January 14, 2004

Re: Former FF/NN Landfill
WDNR License # 467
BRRTS # 02-20-00915

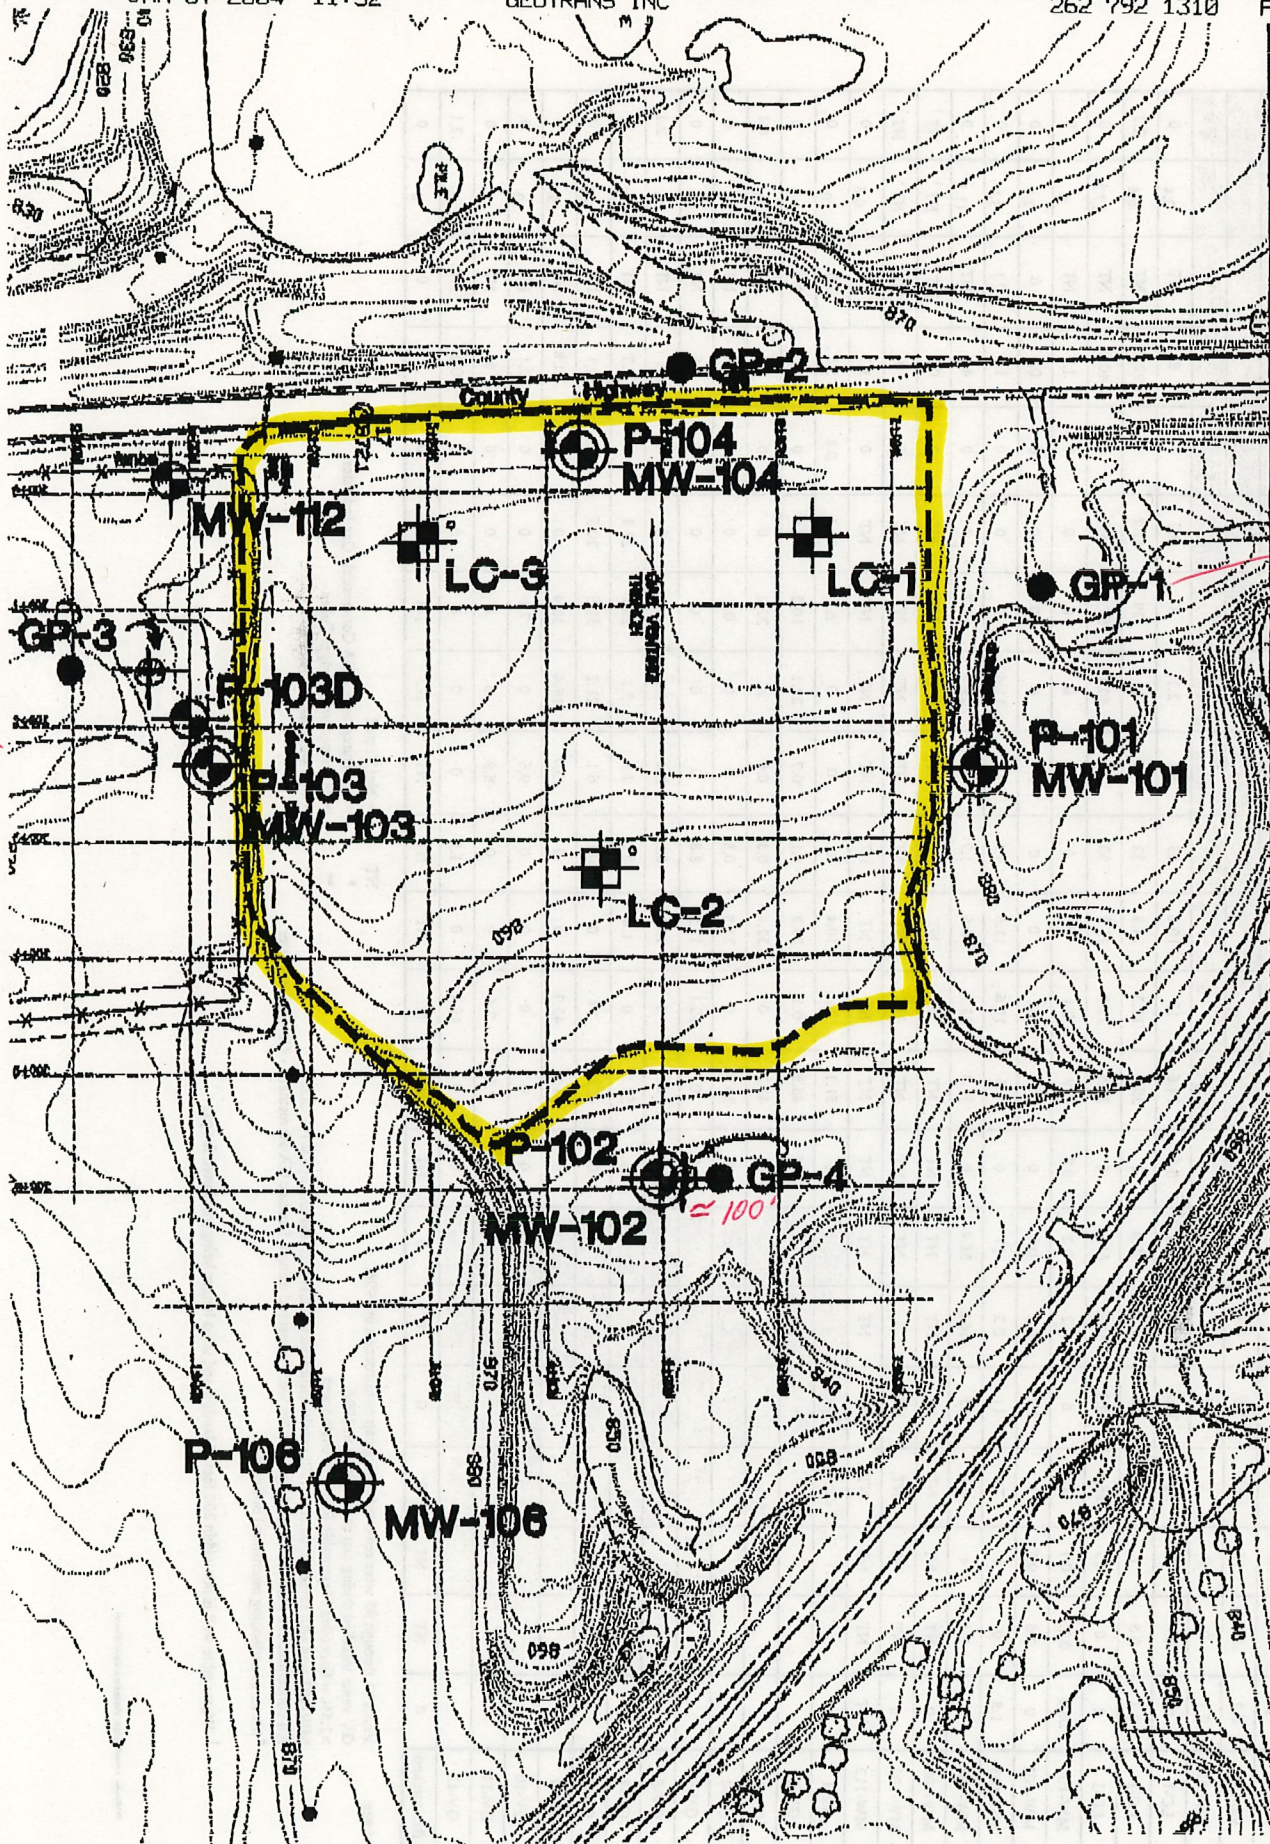
Besides the reasons rooted in sound interpretation of the applicable regulation (NR 507.11), there are practical reasons why we will not place the gas probes at the edge of the waste. In the case of GP-1 (see attached plan view), the gas probe cannot be placed closer than 100 feet from the edge of the waste because locations south of that distance, i.e., closer to the edge of the waste, are overgrown with vegetation and would require tree removal for access. The location of GP-2, which you are apparently satisfied with, is dictated by ownership considerations as well as traffic safety concerns. GeoTrans proposes locating GP-3 approximately 75 feet from the waste to avoid interfering with other uses of the former Bosveld property. GP-4 will be located adjacent to the MW102 well nest, again to avoid a scattering of monitoring devices. This location is approximately 125 feet from the waste's edge.
